AREA WALK-BY CHECKLIST

Location (Bldg, Elev, Room/Area): Area : AUX, 5, CAL-AB-227

Peer Review Checklist for SWEL – Calvert Cliffs Nuclear Power Plant Unit 1

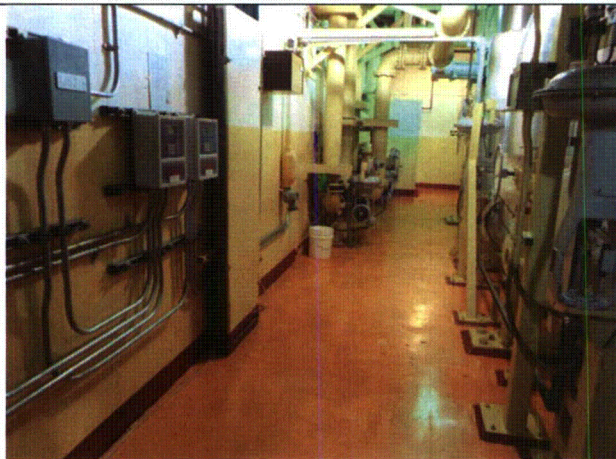
Observed seismic-rated scaffold in area.

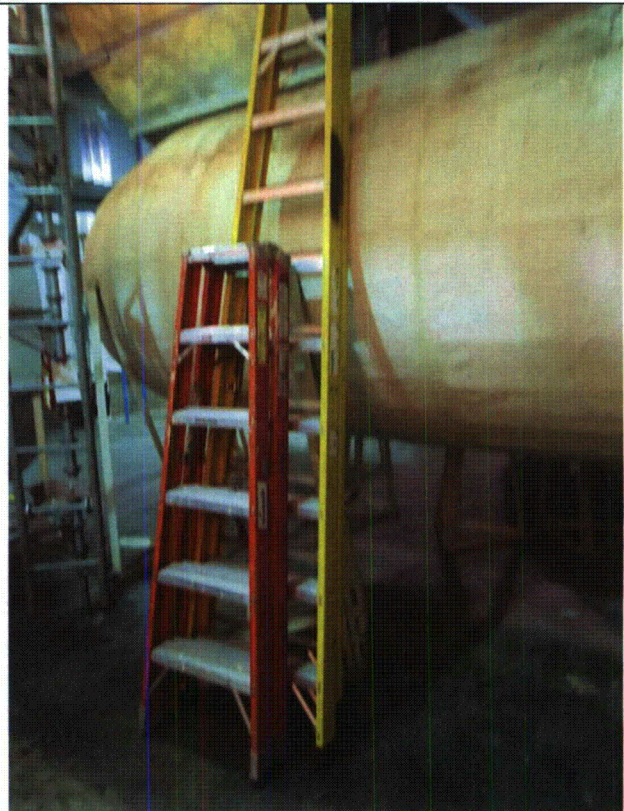
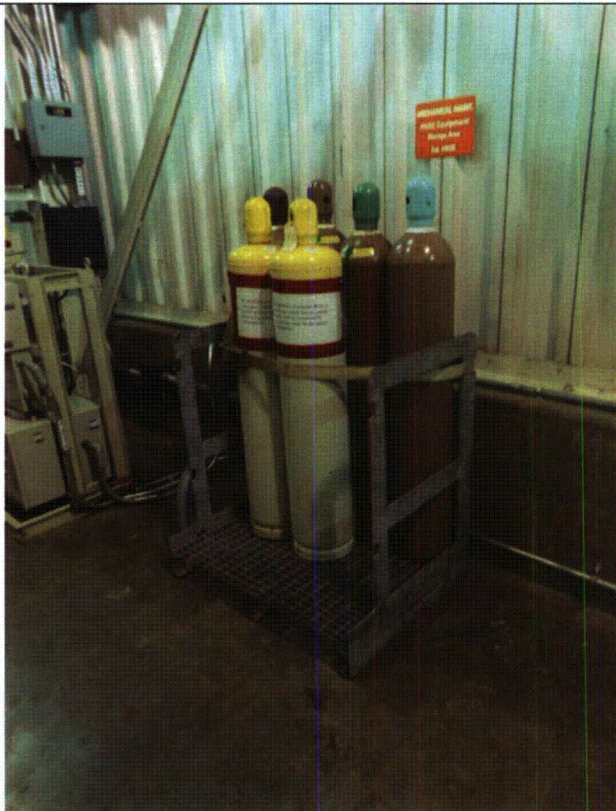
Found unrestrained ladders leaning against equipment and a square washer resting on a concrete pad, although not good housekeeping practices, judged not to be a seismic concern.

Area # DG, 45, CAL-DGB1-DB102 8-15-12 049

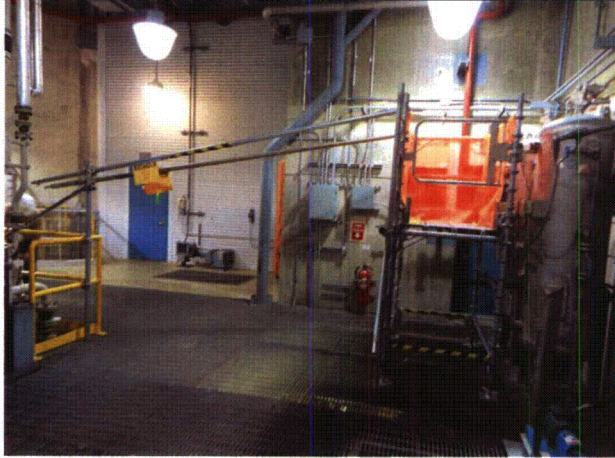
Observed scaffolding without a seismic tag near the starting air receiver, however 3 of the 4 scaffold legs are hooked to the floor grating, one corner is braced to Platform steel, one side is wedged to wall via pipe section, and the platform is braced. SWEs judged the platform may shift and bounce, but will not hit air receivers or associated tubing and devices and therefore not an adverse seismic condition. This condition is similar to Air Receivers 1A2.

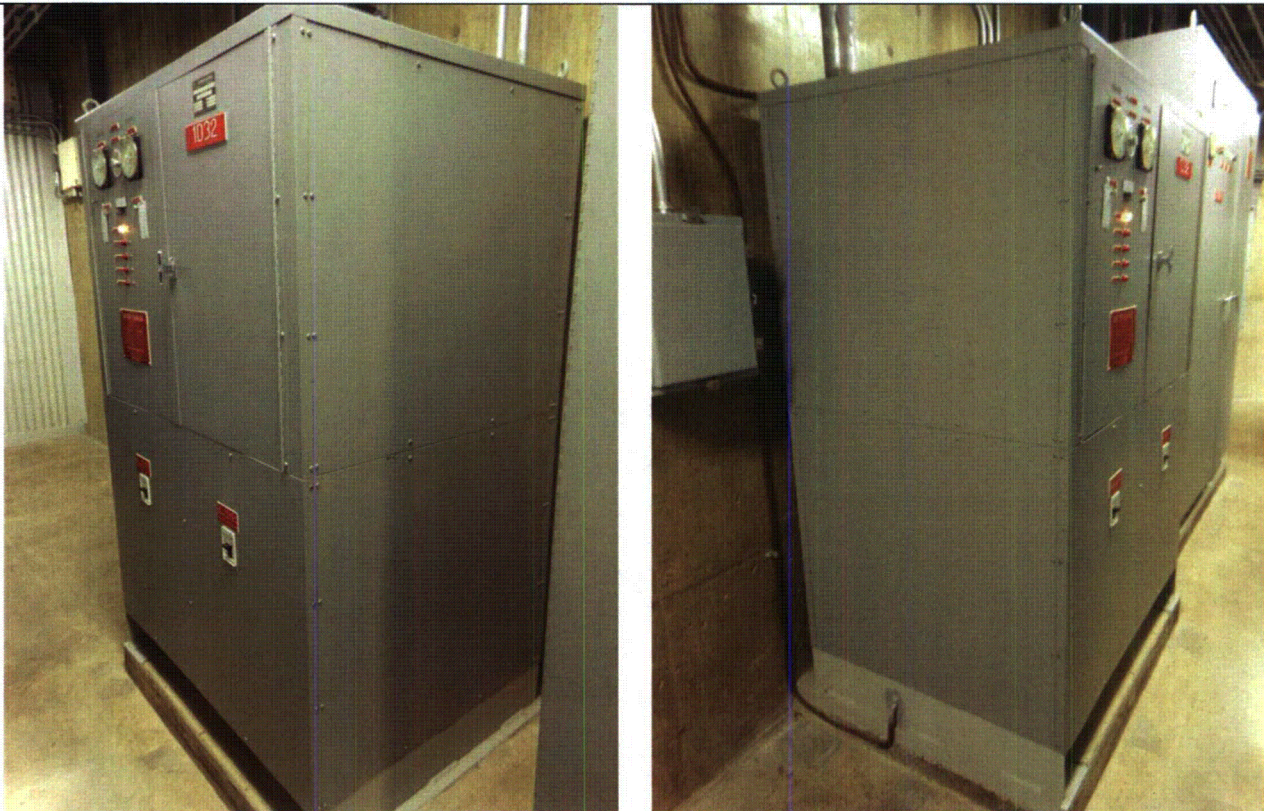
Ops and maintenance equipment are staged in one corner without proper seismic restraint. The equipment will shift and fall to the floor but will not cause an adverse seismic condition and therefore judged acceptable.

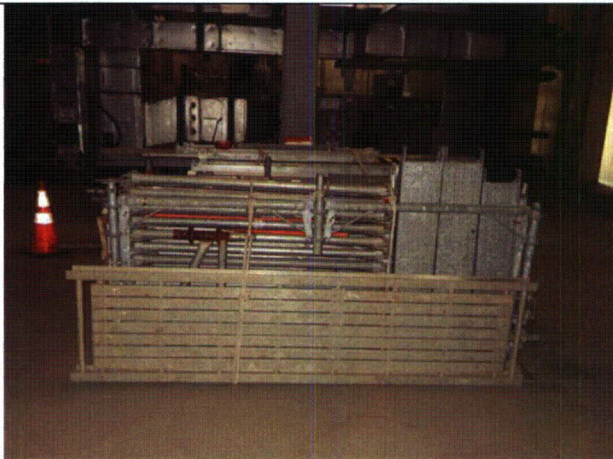
Observed a scaffold storage area far from equipment. Scaffold parts are stored in tube steel bin and within scaffold frame therefore both are judged adequate.

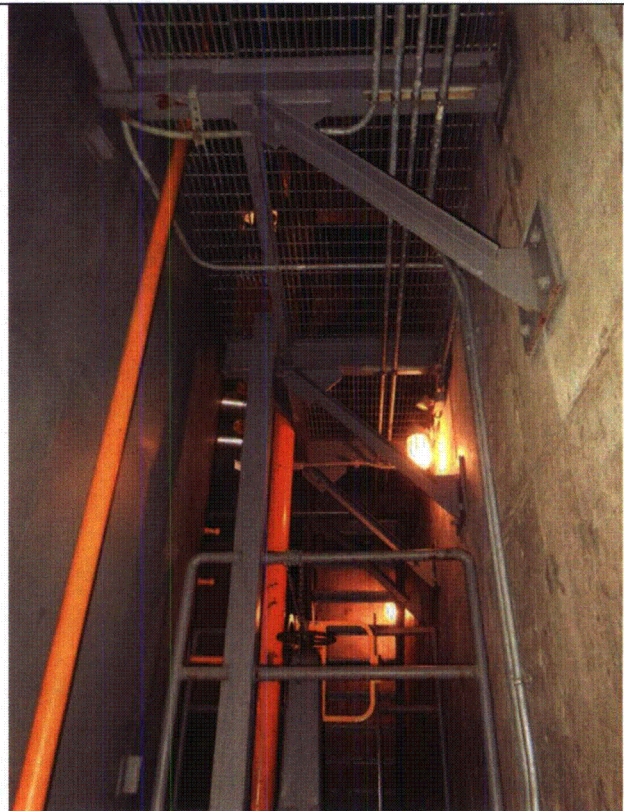
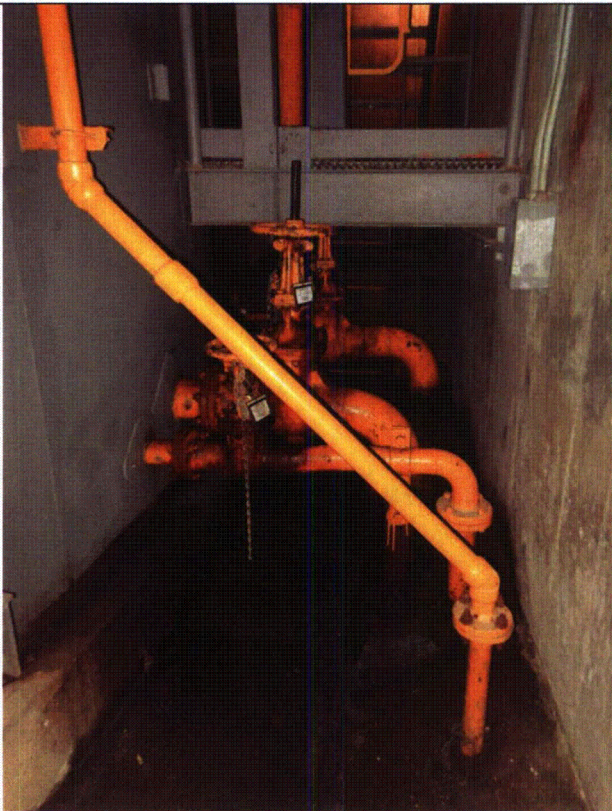
Observed a wrench left on a tank base, but it is not a concern.
